Subject: **Response to Portion of NRC Request for Additional Information Letter No. 103 Related to ESBWR Design Certification Application - Heating, Ventilation, and Air Conditioning - RAI Numbers 9.4-40, 9.4-41, 9.4-44, 9.4-45, and 9.4-46**

Partial Response to RAI Letter No 103 Related to ESBWR

Heating, Ventilation, and Air Conditioning Systems

RAI Numbers 9.4-40, 9.4-41, 9.4-44, 9.4-45, and 9.4-46

Figure 9.4-10 CONAVS Simplified System Diagram

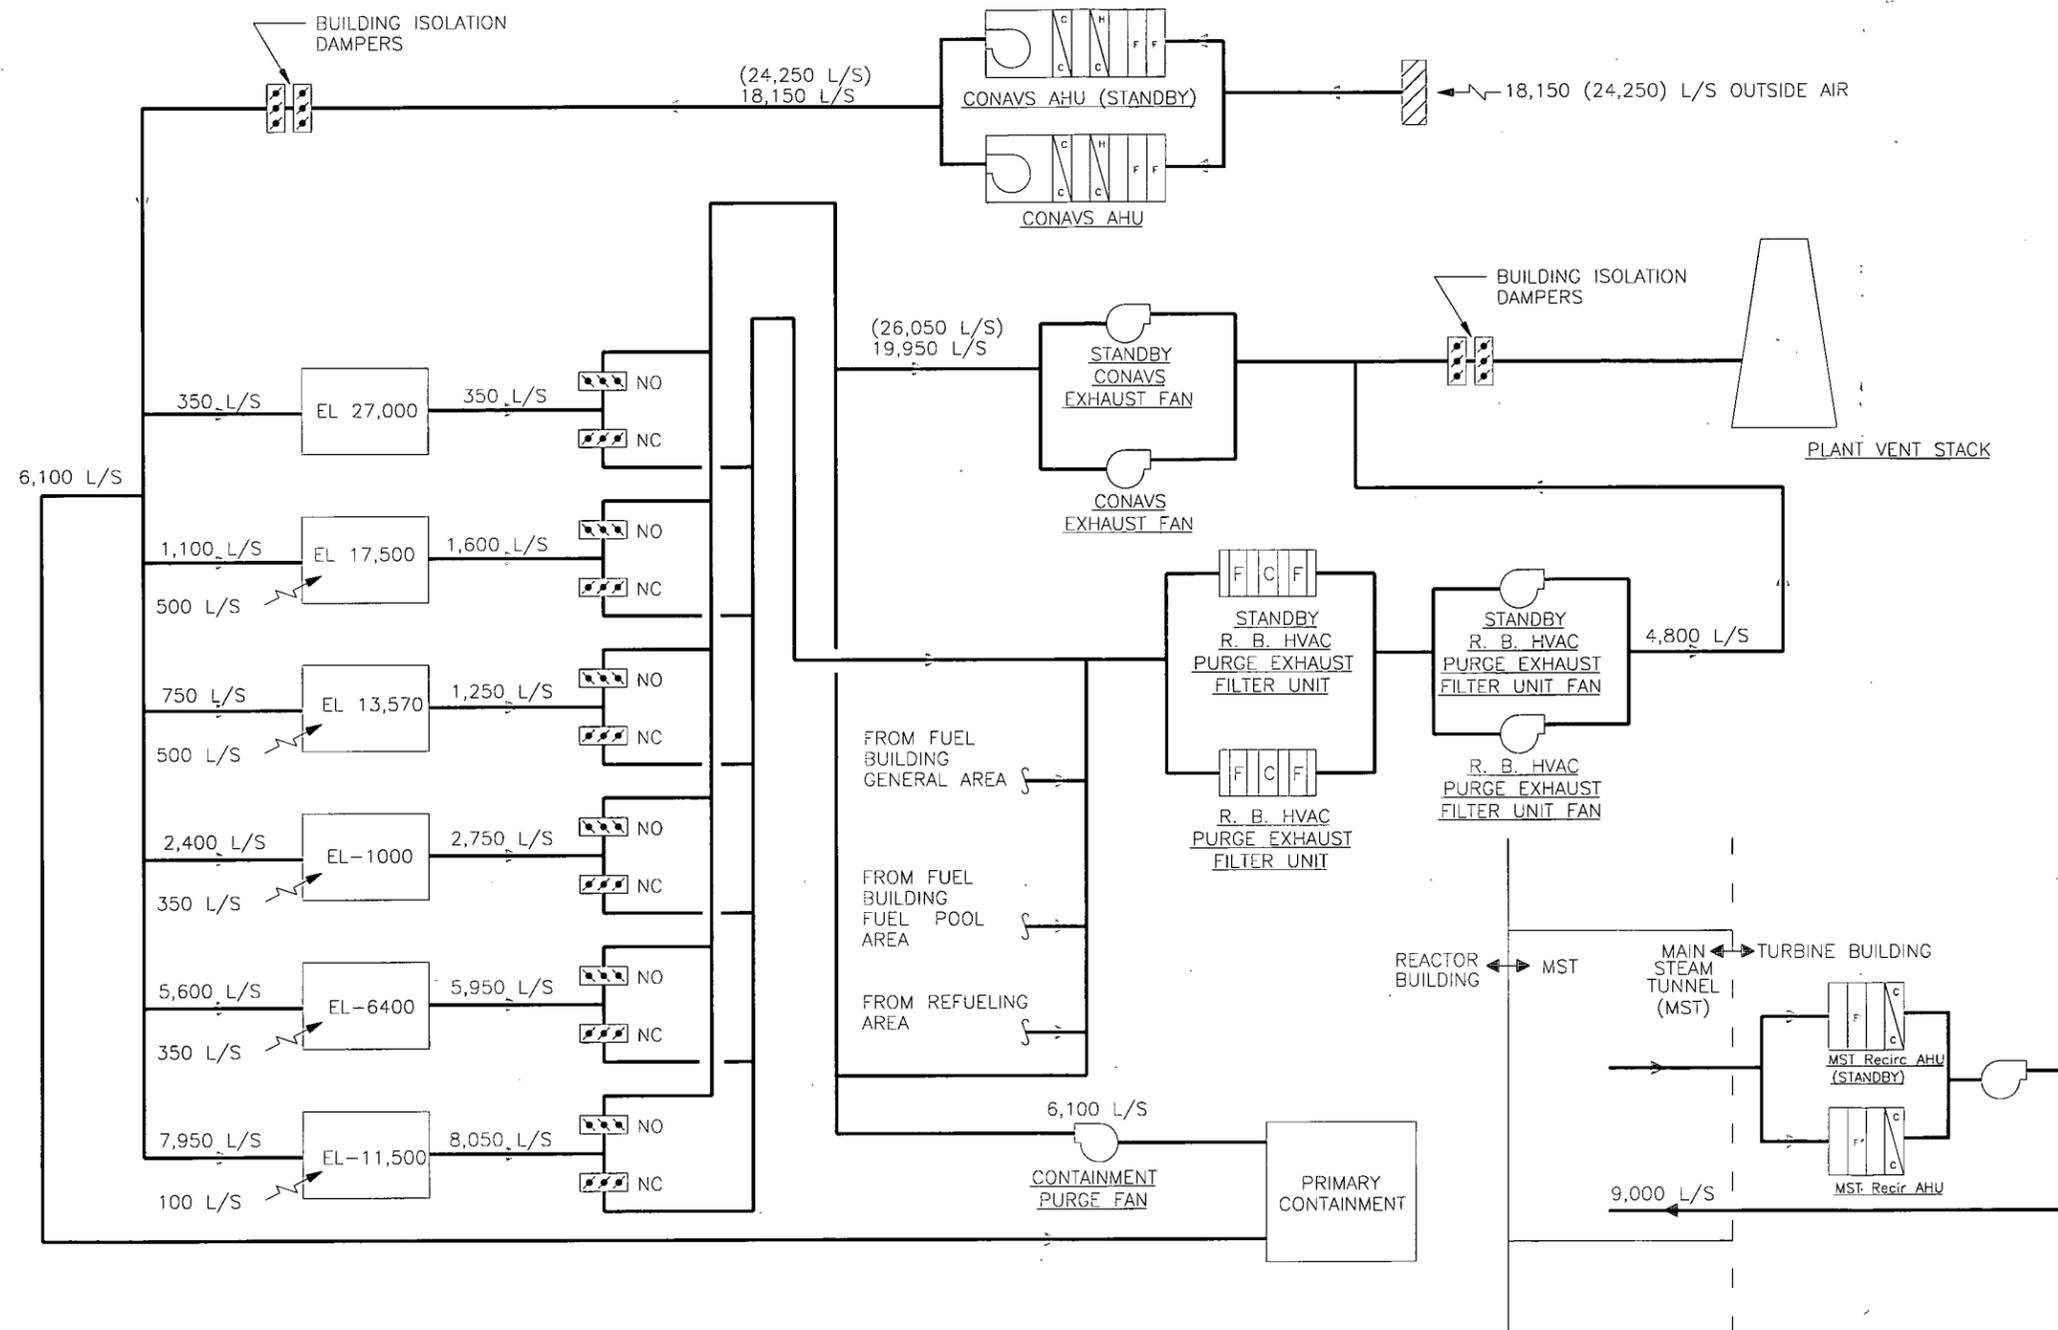
DCD, Tier 2, Revision 3, Table 9.4-11 lists a Main Steam Tunnel AHU, Recirculation AHU and a Refueling Machine Control Room Recirculation AHU as part of the CONAVS equipment.

- A. Please identify these items on the Figure 9.4-10 with respect to other CONAVS equipment.*
- B. The Main Steam Tunnel AHU's are located in the Turbine Building. Are there safety-related dampers for isolation at the Reactor Building interface? Include them on the appropriate diagrams and equipment list.*
- C. The CONAVS AHU's are located in the Fuel Handling Building. Are there safety-related dampers at the building interface? Include them on the appropriate diagrams and equipment list.*

A/B. The Main Steam Tunnel is an open space that connects directly (without air flow restrictions) to the Turbine Building, so there are no safety-related dampers because there is no physical interface between both buildings except for the seismic restraint structure (see DCD Tier 2 Figures 1.2-7, 1.2-10, 1.2-15 and 1.2-20 (room 1770 in the Reactor Building side, room 4393 in the Turbine Building side)). The walls, ceiling and floor of the Main Steam Tunnel provide the boundary between the Reactor Building and the Turbine Building. The Main Steam Tunnel HVAC equipment will be included in DCD Tier 2 Figure 9.4-10. The Refueling Machine Control Room Recirculation equipment will not be included because small equipment is not shown on the system schematic representation.

C. CONAVS has four safety-related isolation dampers at the building interfaces: two in the supply duct (Reactor Building – Fuel Building HVAC Penthouse) and two in the exhaust duct (Reactor Building – Plant Vent Stack). These four building isolation dampers are addressed in DCD Tier 2 Table 9.4-11 and Figure 9.4-10.

DCD Tier 2 Figure 9.4-10 will be revised in the Revision 5, to identify the Main Steam Tunnel Recirculation AHU, as indicated on the attached markup.

Figure 9.4-9 CLAVS Simplified System Diagram

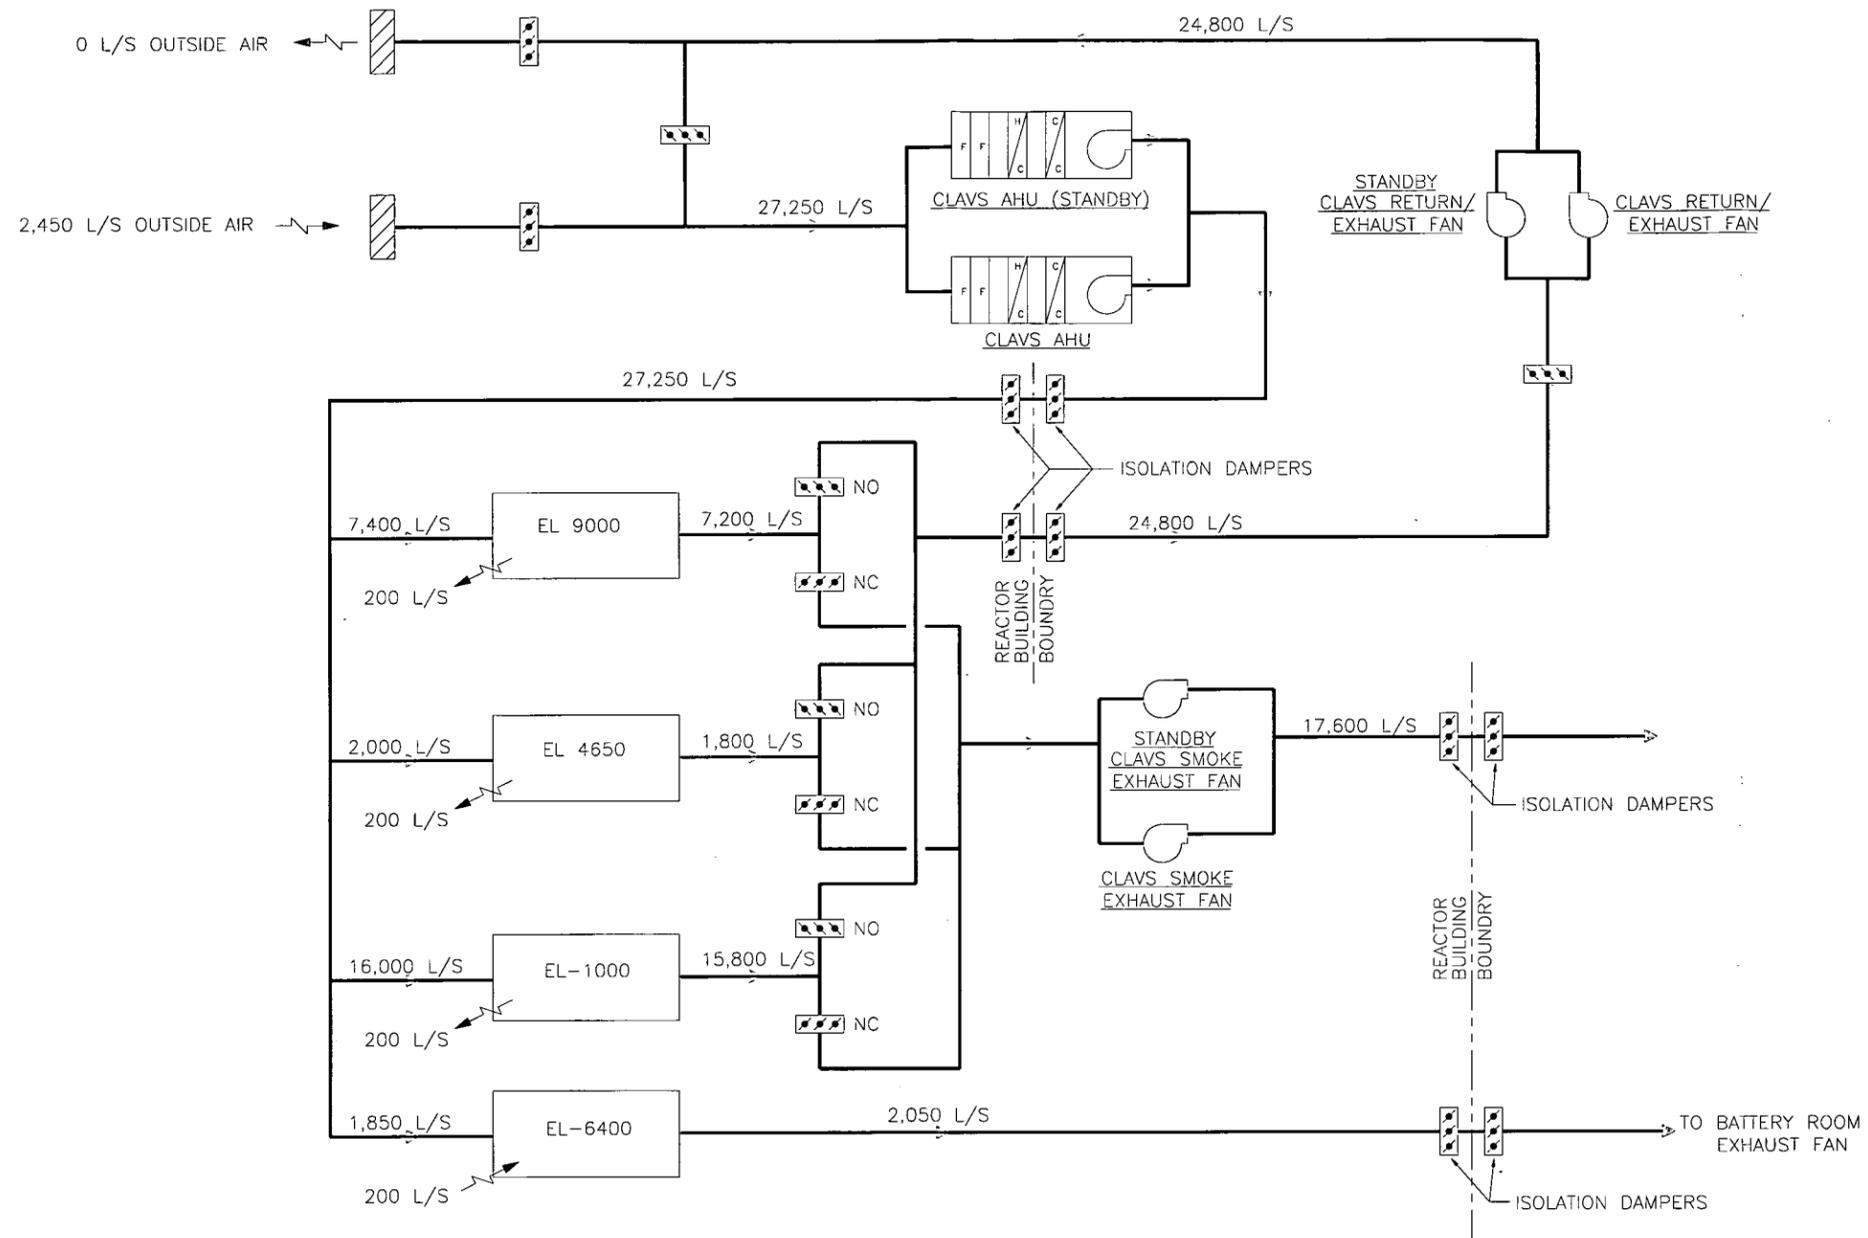
DCD, Tier 2, Revision 3, Figure 9.4-9 indicates that the smoke purge is exhausted directly to the environment.

Include the building isolation dampers and note if they are safety-related in Figure 9.4-9. Since the smoke exhaust could be from contaminated areas, is there any provision to monitor for radioactive release?

It is assumed that fire only affects one fire-area. Therefore the Reactor Building Clean Area HVAC Subsystem (CLAVS) remains in operation except for in the affected fire area. See Revision 4 DCD Tier 2 Appendix 9A for fire area details.

If smoke is detected in rooms served by the CLAVS the smoke exhaust fans extract smoke-air only from the affected rooms, which are clean rooms. Therefore, monitoring for radioactive release is not required. The CLAVS smoke exhaust subsystem is not designed to exhaust smoke from contaminated areas. Since Figure 9.4-9 is a Simplified System Diagram the safety-related designation is not shown on the figure, however, Table 9.4-9 does not show that the Building Isolation Dampers are safety-related. Figure 9.4-9 will be revised to show the building isolation dampers. Table 9.4-9 will be revised to show the CLAVS isolation dampers.

DCD Tier 2 Figure 9.4-9 and Table 9.4-9 will be revised in Revision 5, to include the building isolation dampers, as indicated on the attached markups.
